# Product Change Notice 3M™ Ground Pro Ground Integrity Meter CTM051

Issue Number: 1413

Date: Oct. 10, 2014

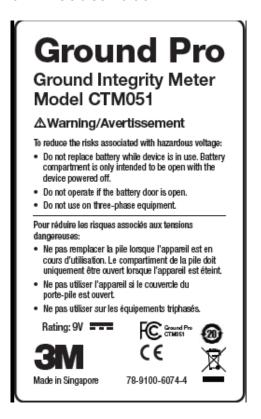
New Product Case:  All new shipments effective immediately will have an updated product case.	UL Flame rating: HB     Battery door without Screw     See attached picture of existing battery door latch (without screw)	1. UL Flame rating: V0 2. Battery door with Screw  See attached picture of new battery door latch (with screw)	Note to existing and new customers:  Do not replace battery while device is in use Do not operate if the battery door is open Do not use on 3-phase equipment
